Regulation No. 129 (Enhanced Child Restraint Systems)

Proposal for the 01 series of amendments

Submitted by the expert from France*

Figure 1
Dimensions in mm of the seat and the seat cushions

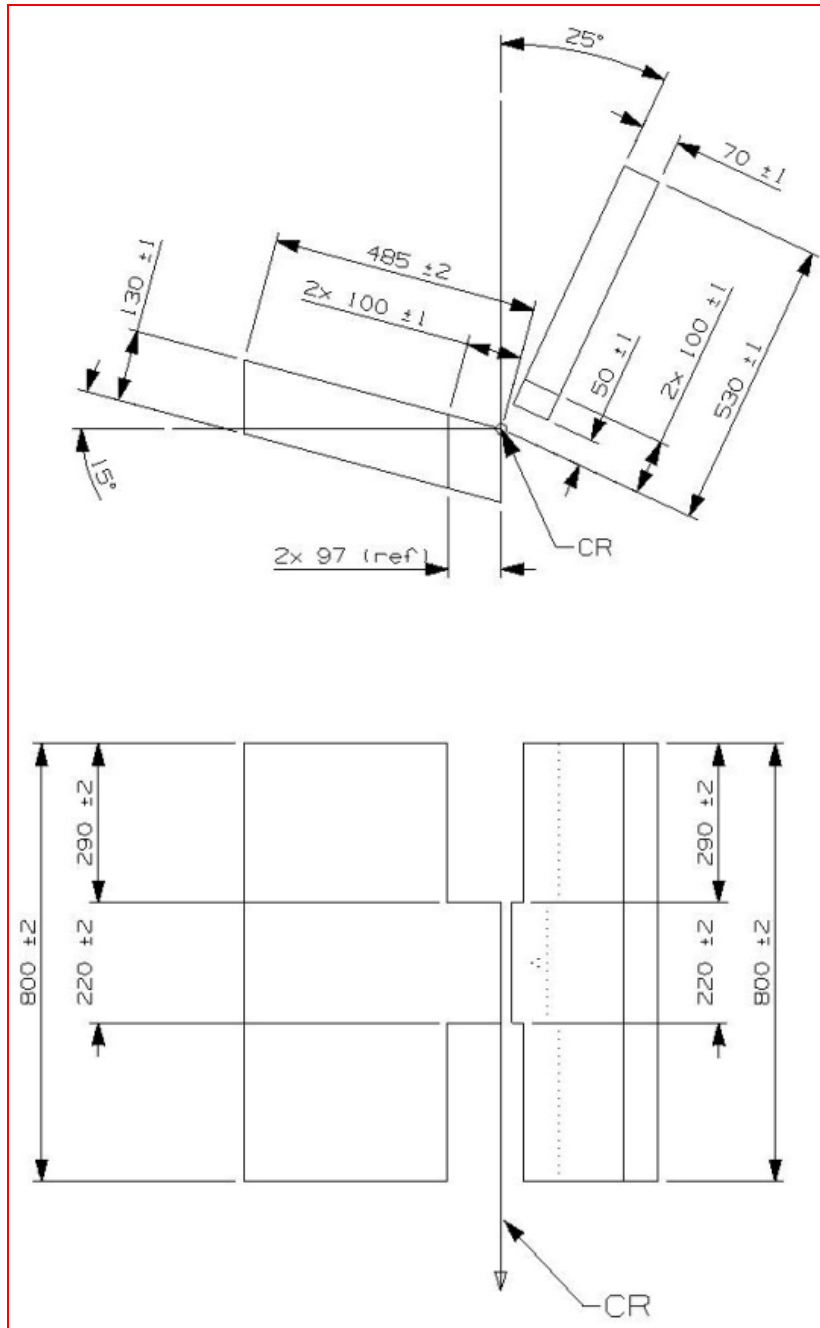
"3.1.2. Rigid seating, **made from a rigid metal sheet**, dimensions of which are given in Appendix 1 to this annex. ~~The rear part of the seating is made from a rigid sheet metal. The front part of the seating is also made of a 20 mm diameter tube;~~"

Figure 1

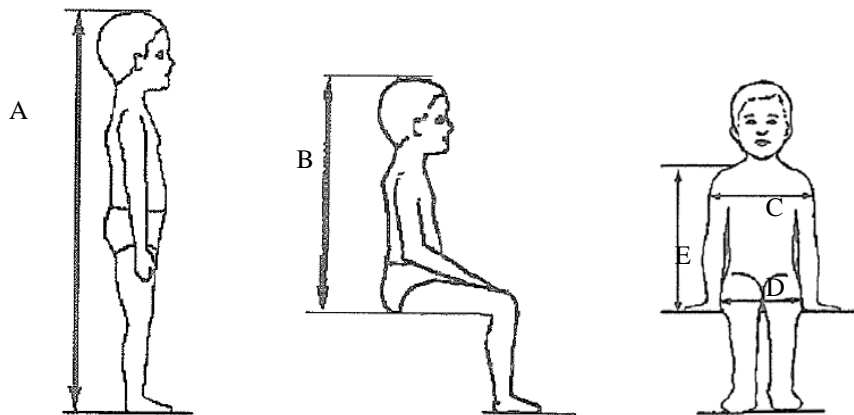
~~When~~ **All lateral dimensions are** measured under a contact force of 50 N with the device described in Figure 2 of this annex **and** the following tolerances will ~~be applied to the dimensions:~~

Figure 1
Standard seat belt configurations

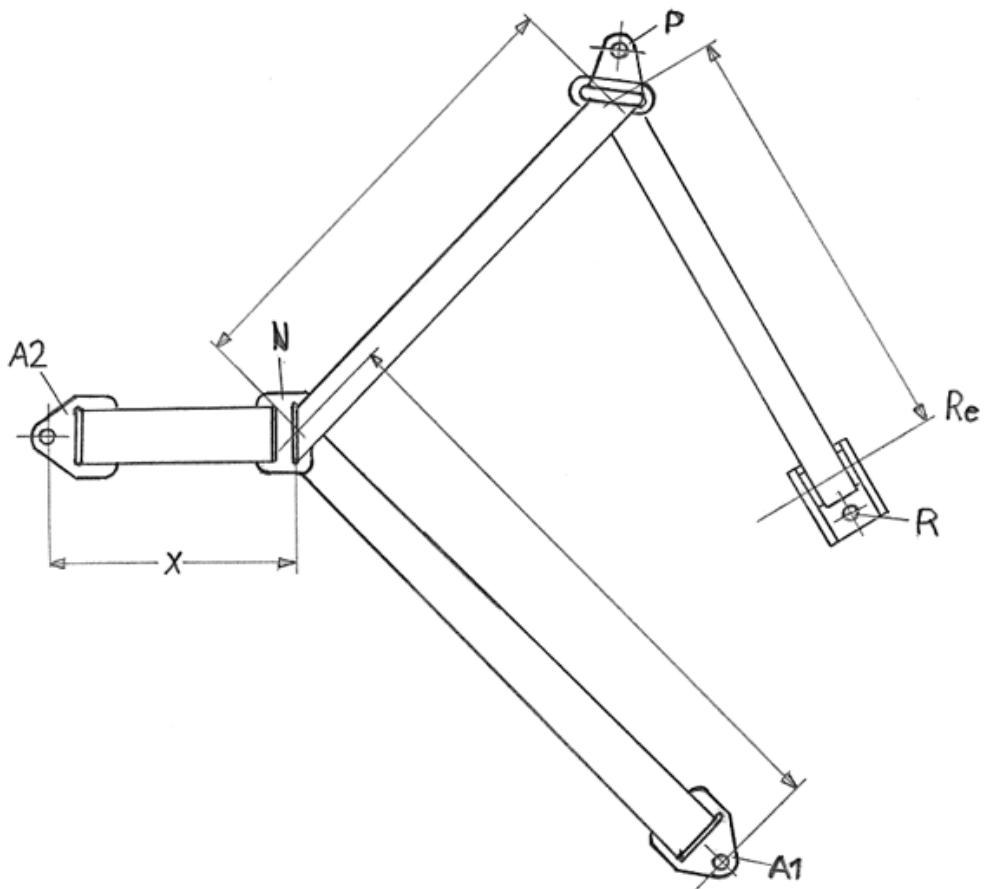
1. The safety-belt for the dynamic test and for the maximum length requirements shall be made according to one of the two configurations shown in Figure 1. These are a three-point retracting belt system.

2. The three-point retracting belt has the following rigid parts: a retractor (R), a pillar loop (P), two anchorage points (A1 and A2) (see Figure 1), and a central part (N, in detail in Figure 3). The retractor shall comply with the requirements of Regulation No. 16 (paragraph 6.2.5.2.2.) for retraction force. The retractor spool diameter is 33 ± 0.5 mm (example is given in Mutual Resolution No. 1 (M.R.1)).

The value of X in Figure 1 below is 200 ± 5 mm. The effective strap length between A1 and the centre line of the retractor spool Re (when the webbing is fully extracted including the minimum length of 150 mm for testing of Enhanced Child Restraint System shall be $[2820] \pm 5$ mm when measured in a straight line without load and on a horizontal surface. This length may be increased for the testing of restricted categories; for all categories with the Enhanced Child Restraint System installed, there shall be a minimum of 150 mm of strap length on the retractor spool.
